H2Teesside Project

The H2Teesside Order

Document Reference 7.1: Change Notification

Date: August 2024

Notification of Proposed Changes
Detailed
Key Plan

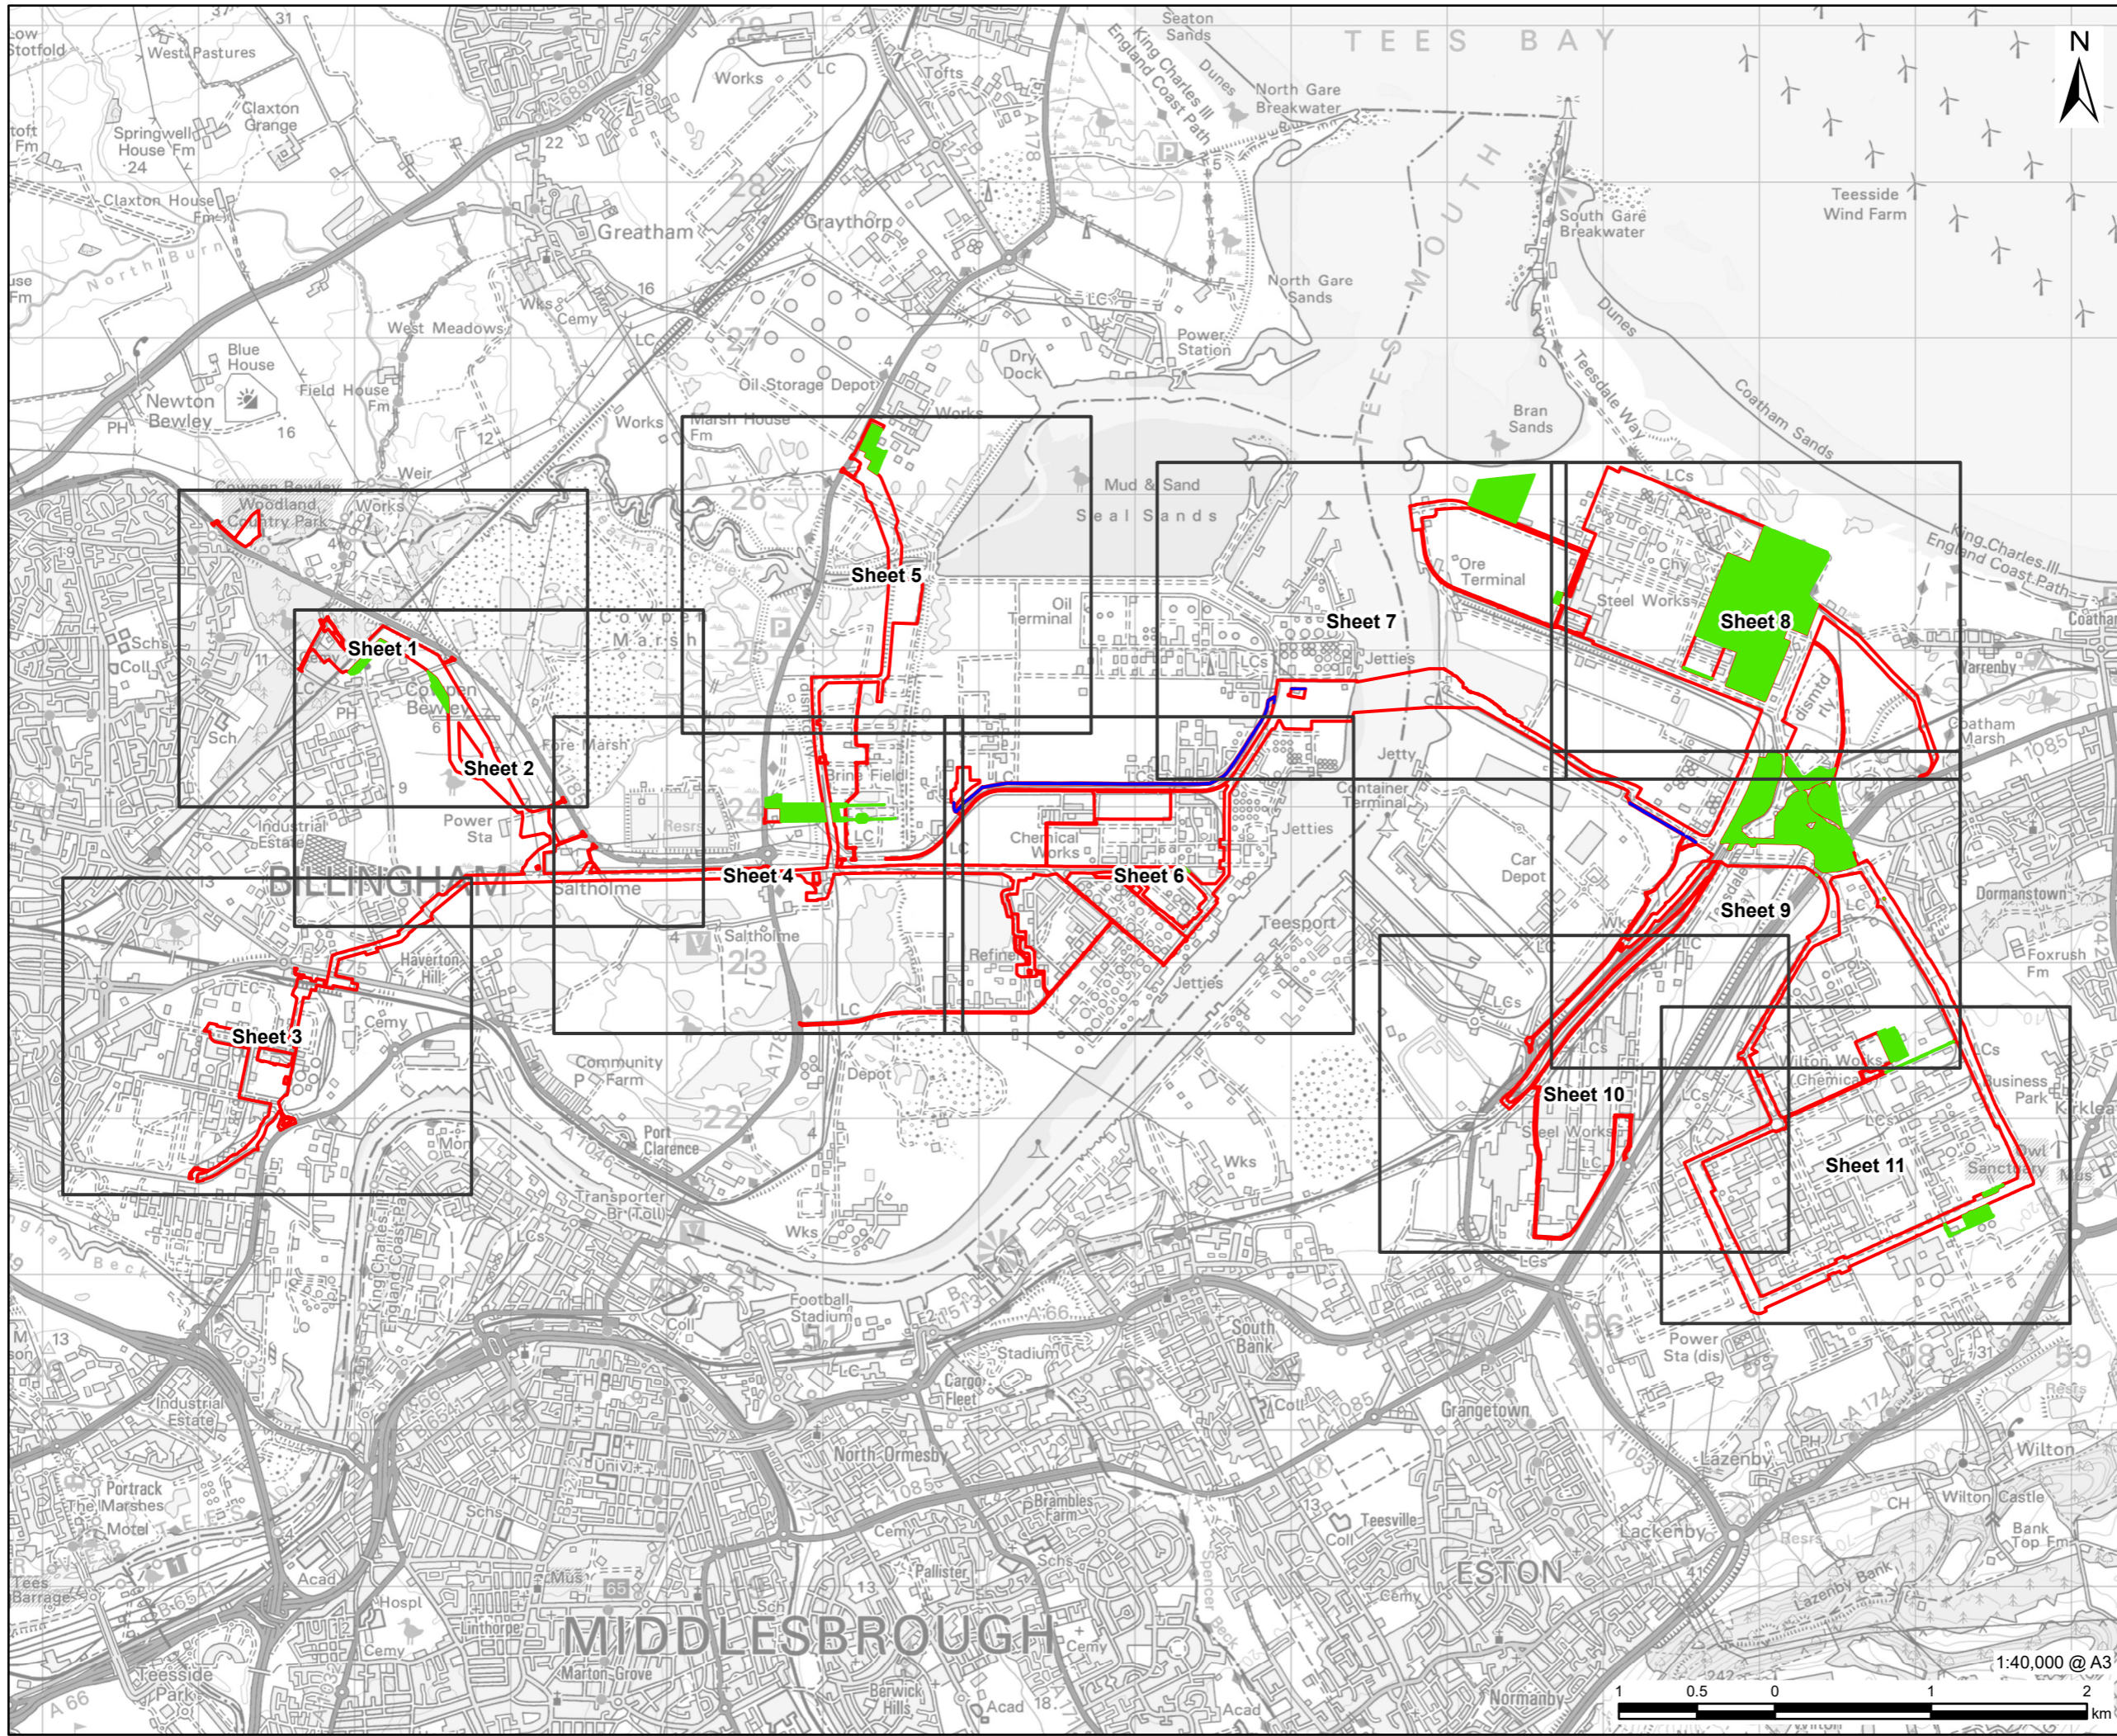
- 2.3.9 The proposed changes are explained in more detail below, including the rationale and justification for each change. The location and extent of the proposed changes and the corresponding updates to the Order Limits are shown on the plans at **Appendix 1**. These show the land being removed from the Order Limits (as per the DCO Application submitted in March 2024) shaded in green, additional land that it is proposed to include in the Order Limits (Change 8) shaded in blue and the proposed extent of Order Limits outlined in red. The plans comprise a Key Plan and Sheets 1 to 11 showing the changes in more detail.

Sheet 4 of 11

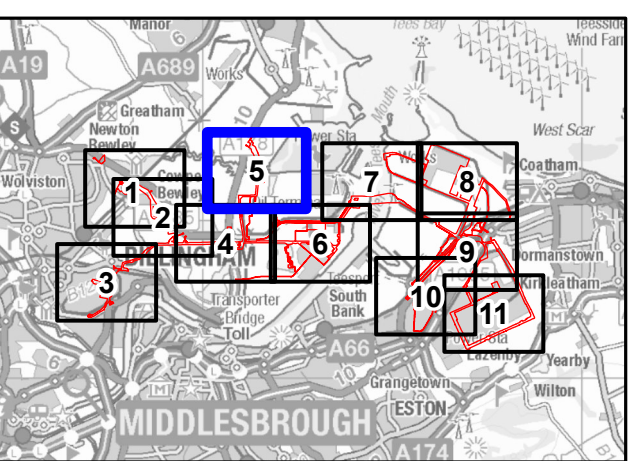
- 2.4.8 The proposed change will result in a reduction of 2.5 ha in the Order Limits, with the Order Limits following the boundary of Work No. 6A.2.
- Change 2.B – Reduction at Venator Work Nos. 6A.1 and 6B.1) – Category 'C'

- 2.4.9 This change will reduce the Order Limits at the terminus of the Greatham branch of the Hydrogen Distribution Network Pipeline corridor, which comprises work areas for the pipeline corridor (Work No. 6A.1) and the AGI it connects into (Work No. 6B.1).

- 2.4.10 This change is a result of design refinement and discussions with the landowner, Venator, to minimise impact on its operational plant.
- 2.4.11 The proposed change will result in a reduction of 2.5 ha in the Order Limits.
